## Network Camera Firmware Version: V5.8.10 Release Note

<b>Firmware</b> <b>Basic Information</b>	Firmware Version:	V5.8.10 build221108
---	-------------------	---------------------

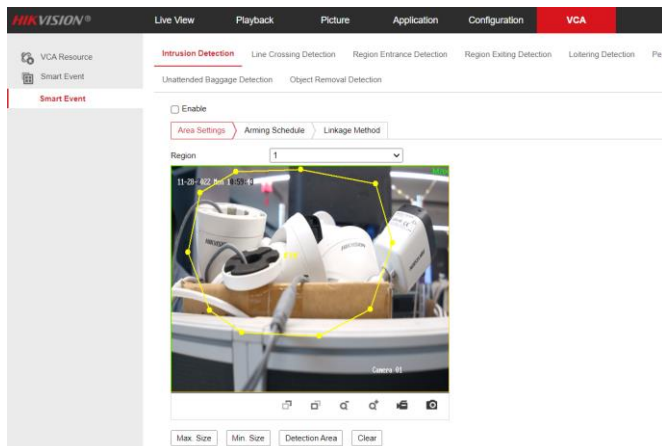
- Support metadata on Multi-Target-Type Detection mode.

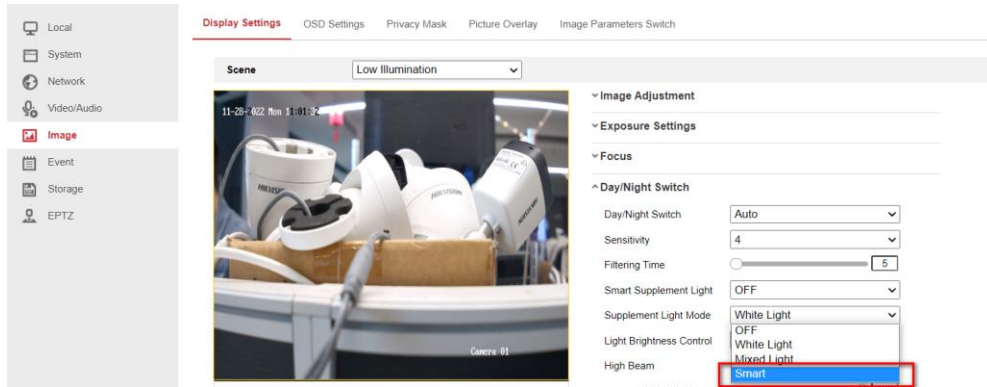
- Support drawing polygon detection area on Smart Event mode, maximum support 10 sides.

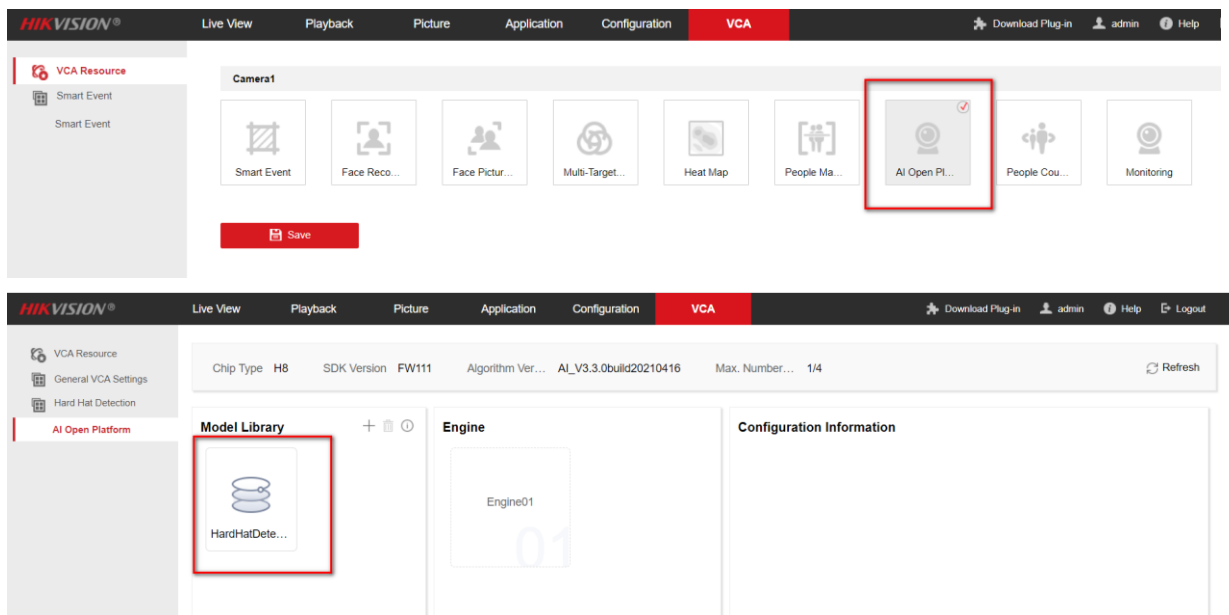
- Support smart supplement light on Smart Event mode, the default supplement light is IR, when the alarm is triggered, it can switch to white light mode. (Only for 7xx7 model)

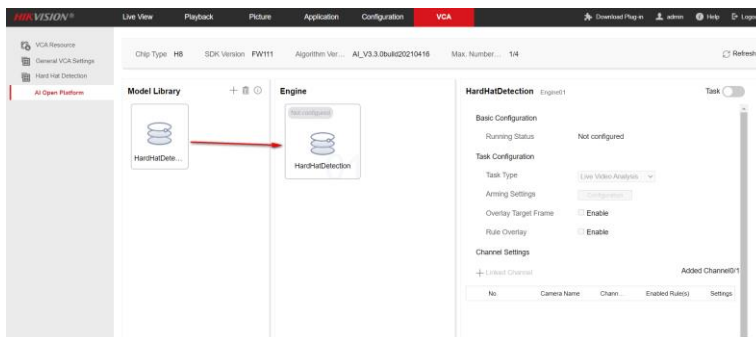
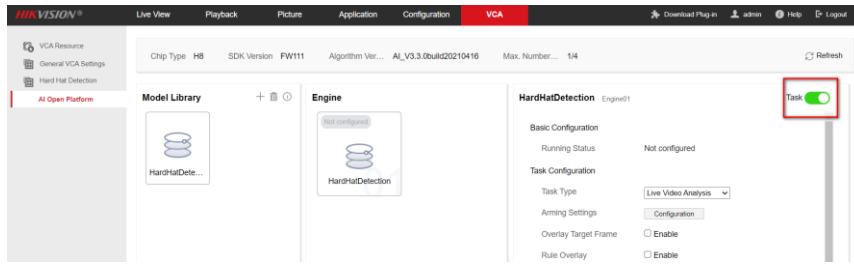
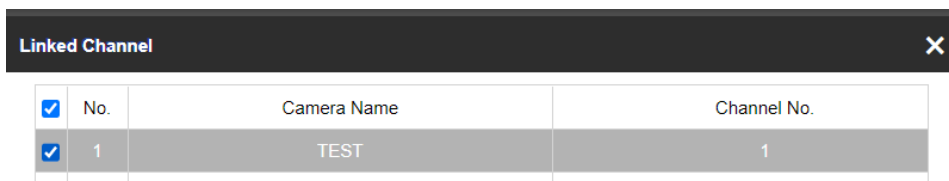
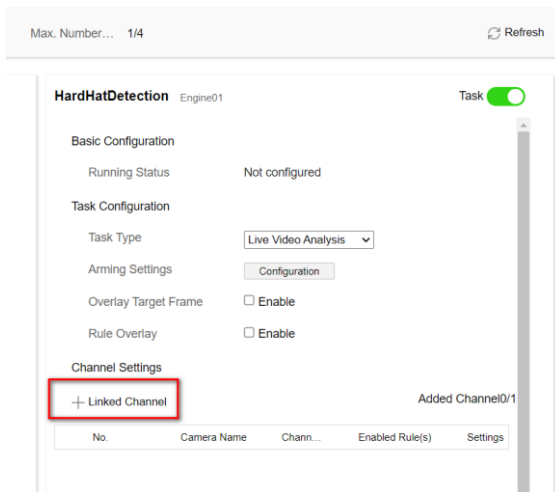
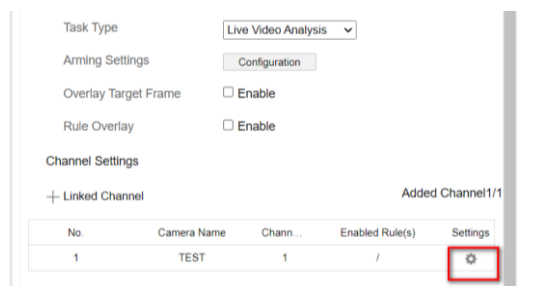
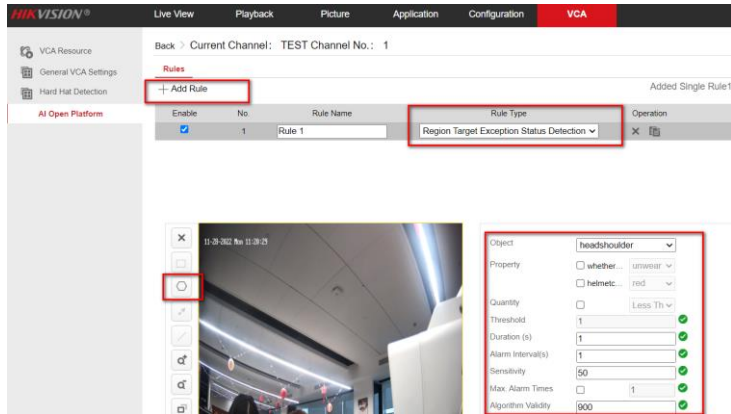
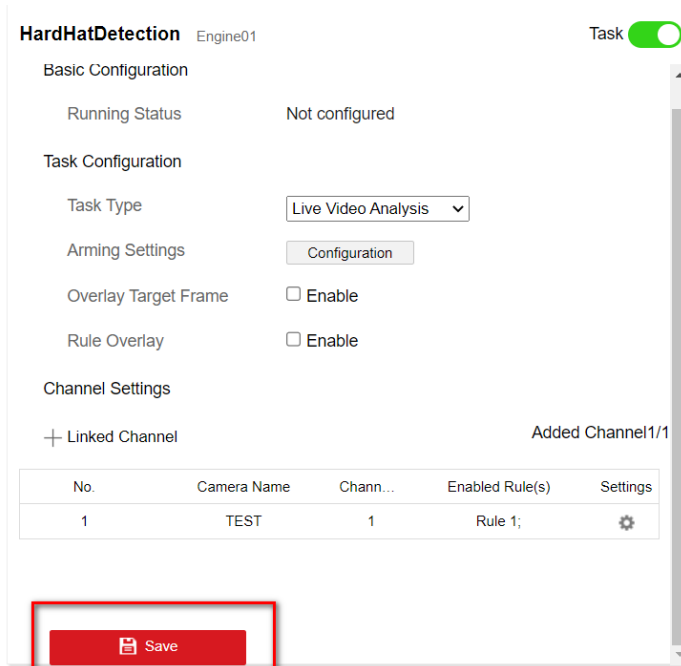
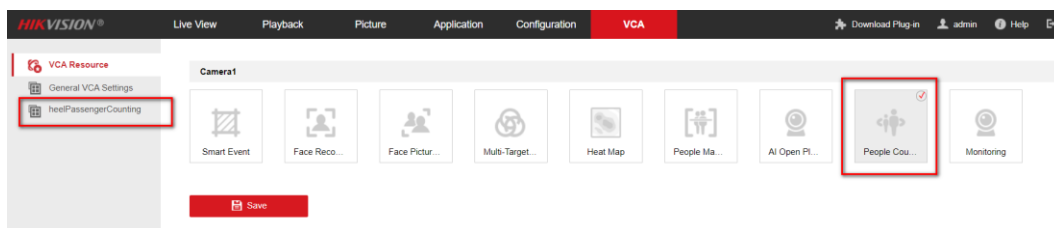
- Newly add AIOP mode with built-in hard hat detection algorithm.

- **Hard Hat Detection:** it detects targets in the set monitoring region who do not wear the hard hat and triggers an alarm.

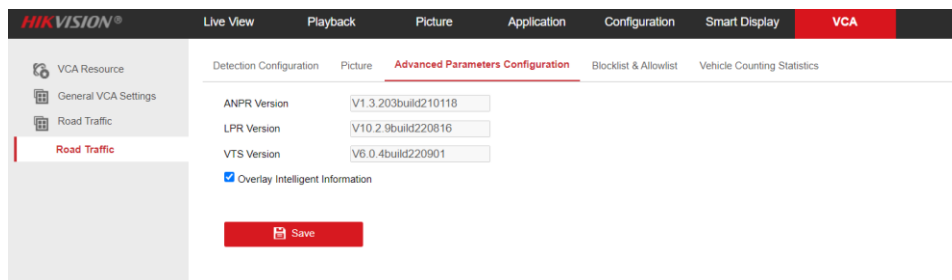
- Support enable POS on web: Clicking Overlay Intelligent Information on VCA→Road Traffic→

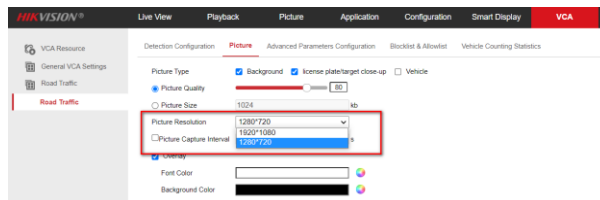
- Support display algorithm version on web: VCA→Road Traffic→Advanced Parameters Configuration displays ANPR Version, LPR Version and VTS Version.
- Support set the capture of the background image resolution.

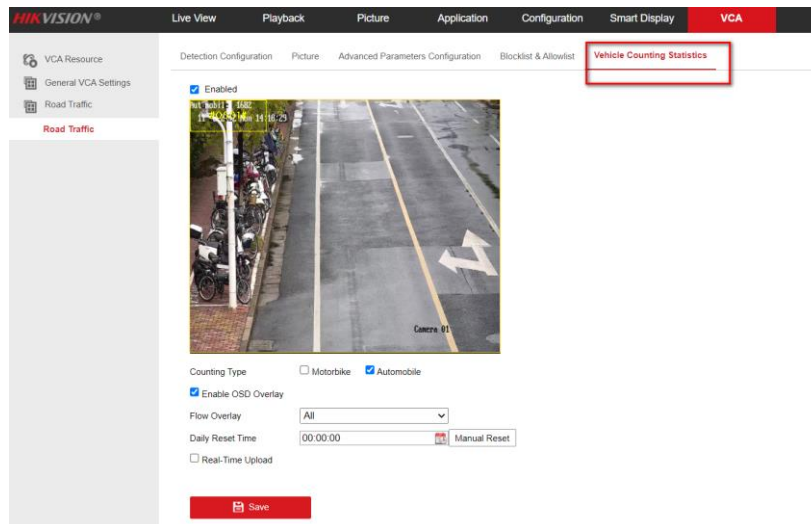
- Newly add Vehicle counting function.
